Acceptance Notice for the Proposed
Kawainui Marsh Flood Control Project
Final Environmental Impact Statement (Final EIS)

**KAWAINUI MARSH
FLOOD CONTROL PROJECT
KAILUA, ISLAND OF OAHU, HAWAII**

**FINAL DETAILED PROJECT REPORT AND
ENVIRONMENTAL IMPACT STATEMENT FOR
KAWAINUI MARSH FLOOD CONTROL PROJECT**

FIGURE 3 (Sheet 1 of 5)

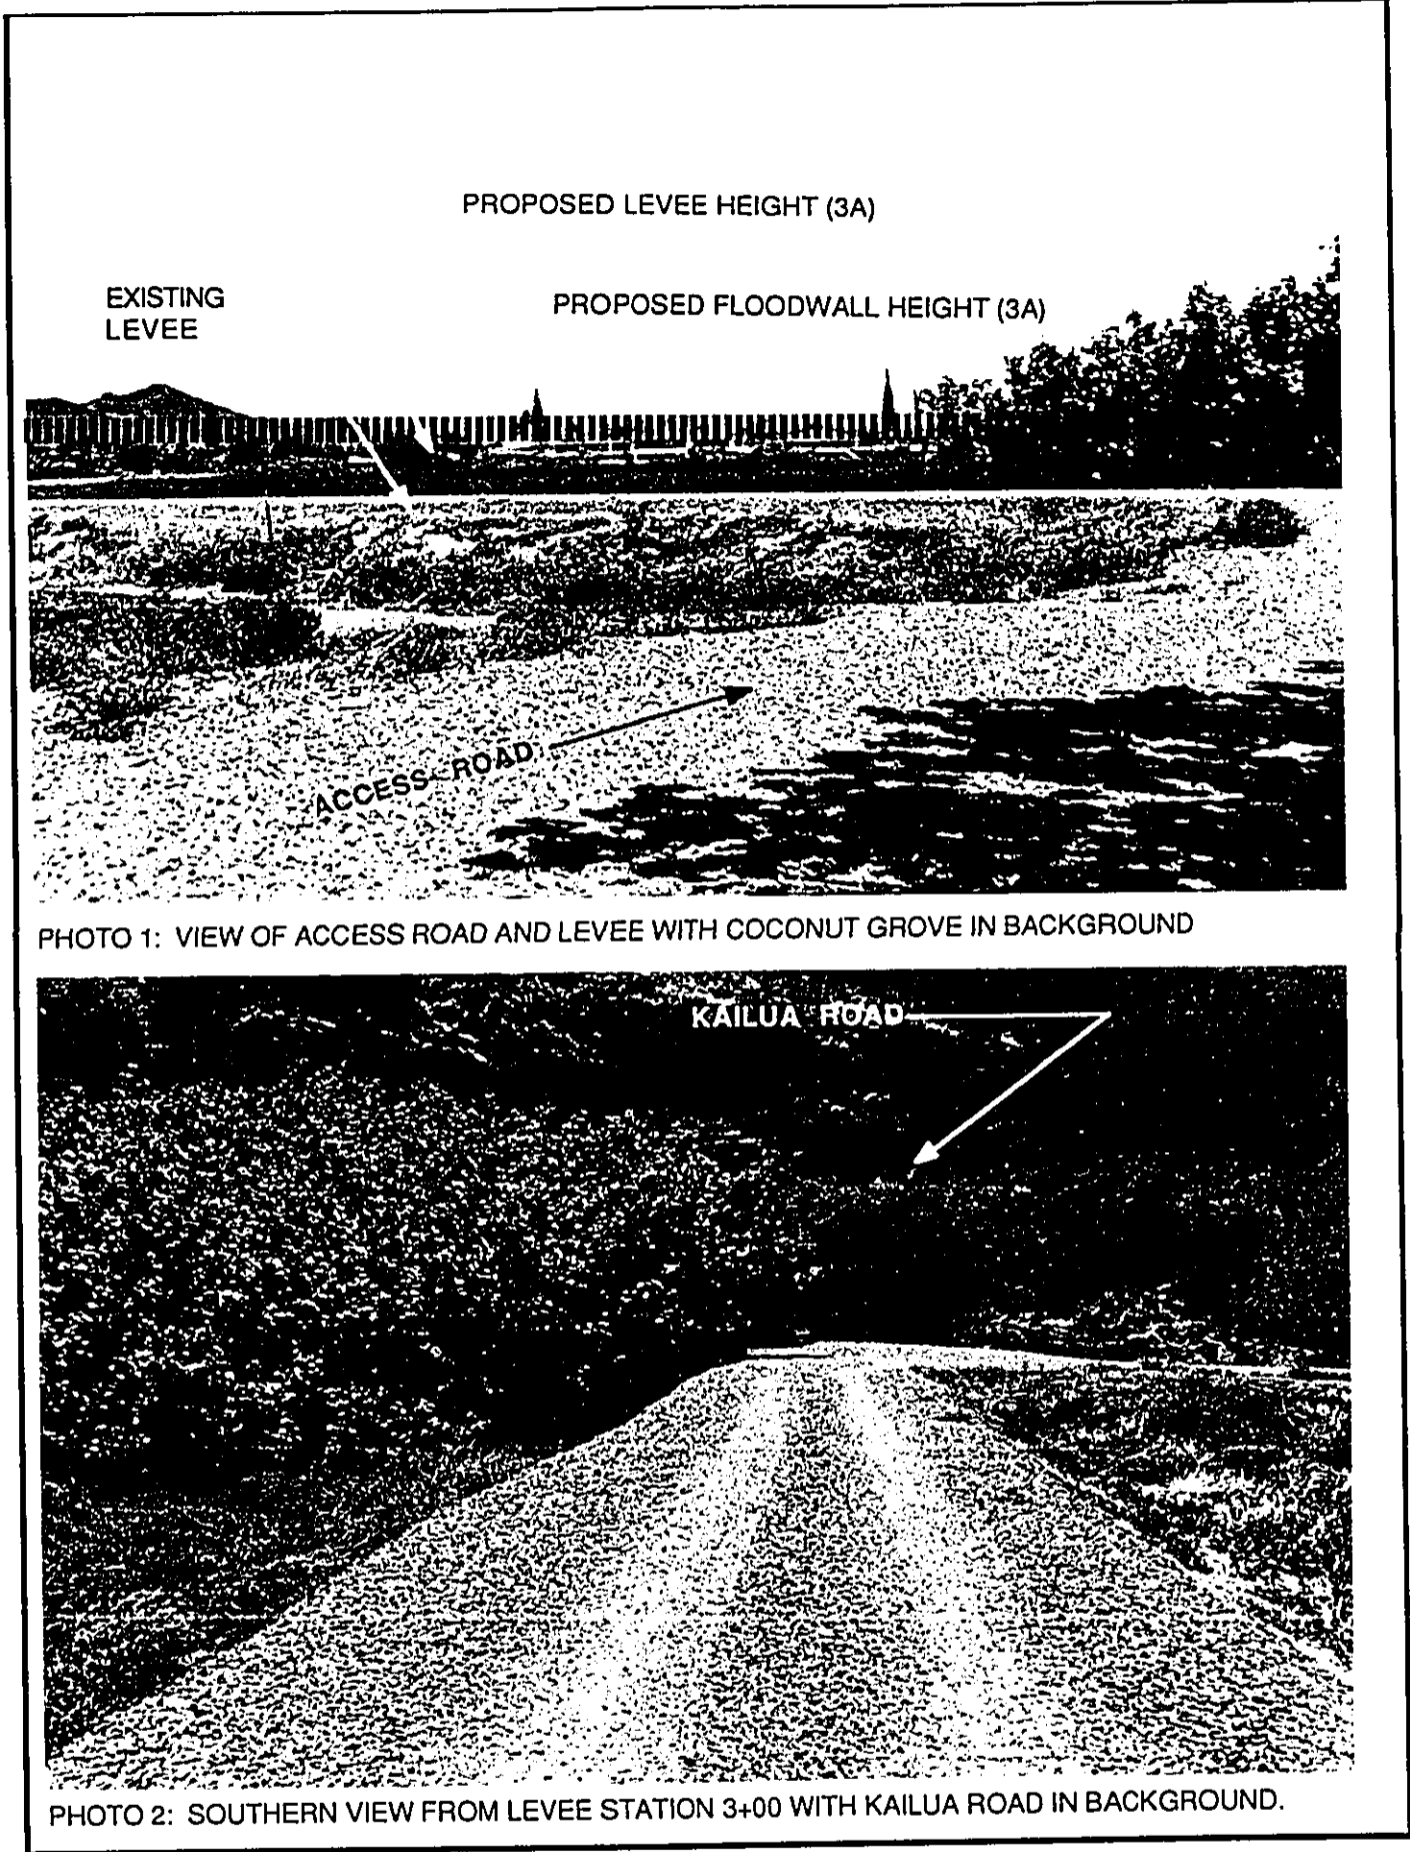
The photos provided in Figure 3 of the project report might be used to reflect the visual impact of the proposed concrete wall if the wall was artificially inserted through computer generation or by photographic "doctoring."

U.S. ARMY ENGINEER DISTRICT, HONOLULU
 FIGURE 9

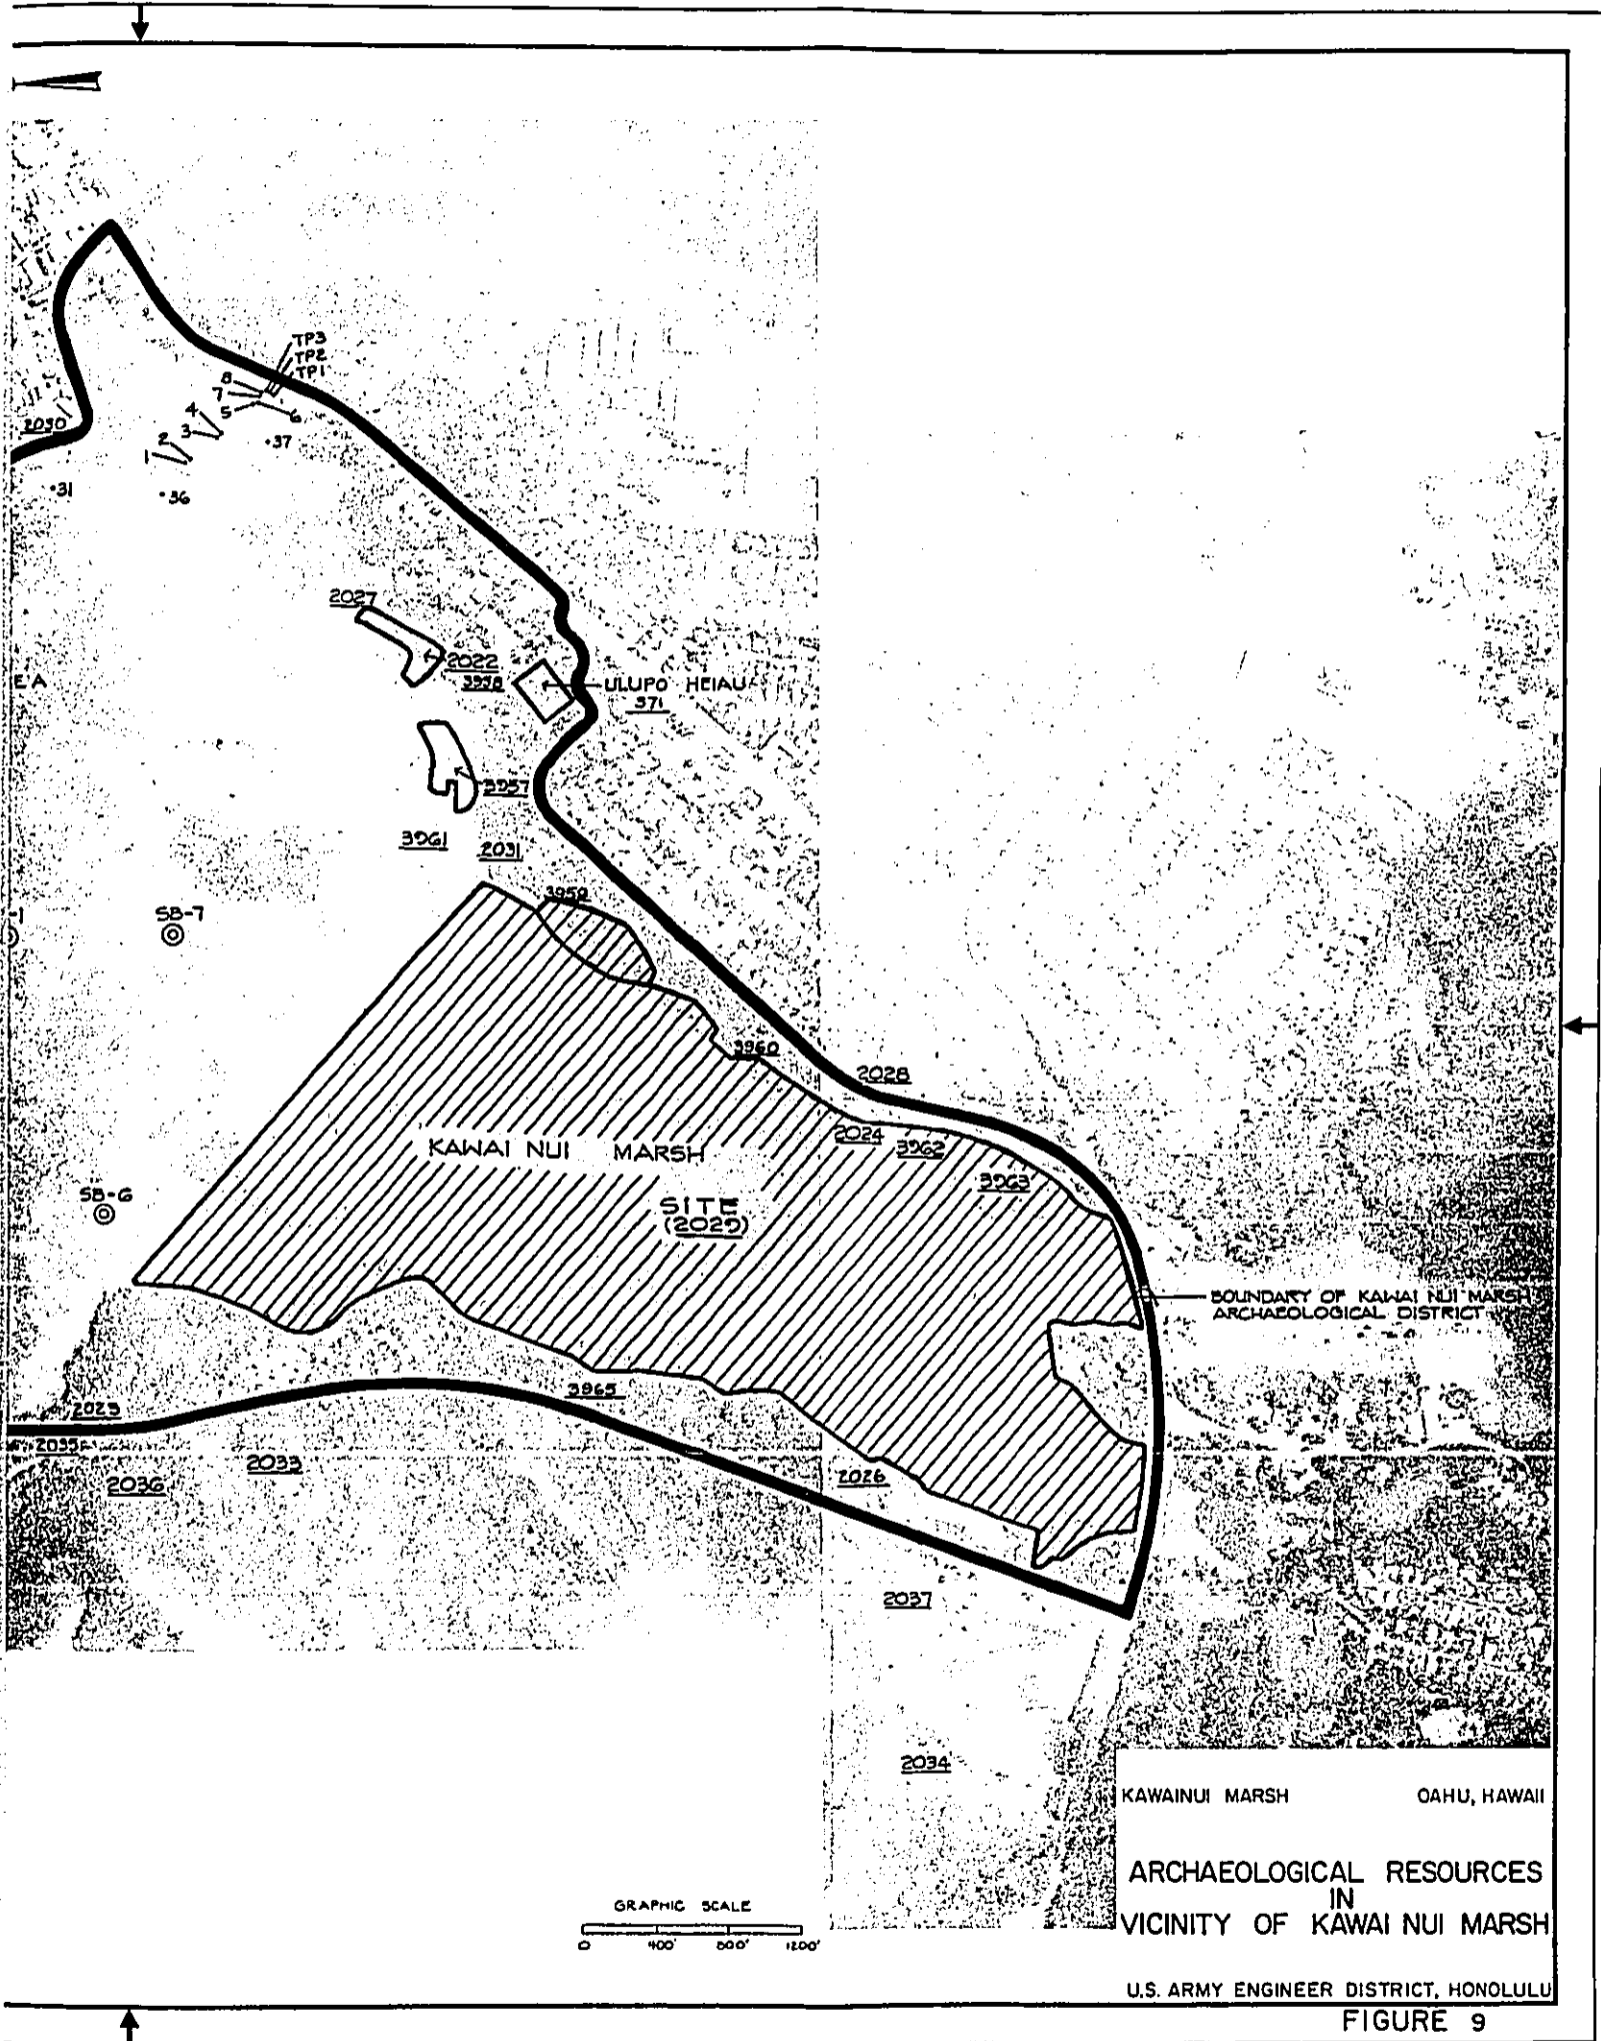
1. Figure 10 - "Archeological Resources in the Vicinity of Kawaiinui Marsh." The National Register boundary shown for Kawaiinui Marsh was arbitrarily established in 1979 using aerial photographs rather than through standard scientific pedestrian survey and testing. The extent of modern disturbance on well as the extent of archeological sites was not known at that time and it is not known now. The marsh, however, has long been recognized as part of a larger and highly important prehistoric cultural and economic unit. Not all Hawaiian archaeologists agree with the currently depicted boundary, some believing the entire watershed should form the National Register archeological district.

3. Surveys should be conducted in all potential project impact areas regardless of the survey boundaries depicted in Figure 10. For example, very little is known archaeologically about the western half of the archeological district, and random burials are known to occur in the Kailua flood proofing zone (Plan 6) which is outside the boundary

(b) Please verify that the second-hand rendering of the boundary of the so-called "Kawai Nui Marsh archaeological district" in Figure 10 of the Draft EIS is the same one that was accepted by the Keeping of the the National Register in 1979. I recommend that you include the text and map of the original eligibility determination in the Appendix of this EIS and consult it directly when making an assessment of affect.

1. The National Register boundary shown in Figure 10 is the official boundary of the historic site as shown on the request for eligibility submitted to the Keeper. Although some archaeologists may believe the boundary should be drawn differently, no amendment to the eligibility request has been submitted.
2. Our NEPA document has incorporated by reference the previously prepared state EIS published in June 1990 by our local sponsor, the City and County of Honolulu, as stated in our joint federal/state draft EIS. Additional archaeological survey and coring data for the interior of Kawaiinui Marsh associated with that study are available from the City and County of Honolulu. During the planning process, it became apparent that neither the in-marsh nor the floodproofing alternatives would be feasible because of economic, engineering or environmental considerations.

boundary shown in Figure 10 is the official boundary of the historic site as shown on the request for eligibility submitted to the Keeper. The findings from our draft archaeological report were summarized in the DEIS appendix. It is available in final form and you were sent a copy in July, 1991. We have included the Hawaiian name attributed to Kridler's rock in the PEIS and corrected the spelling of Pohakupu.
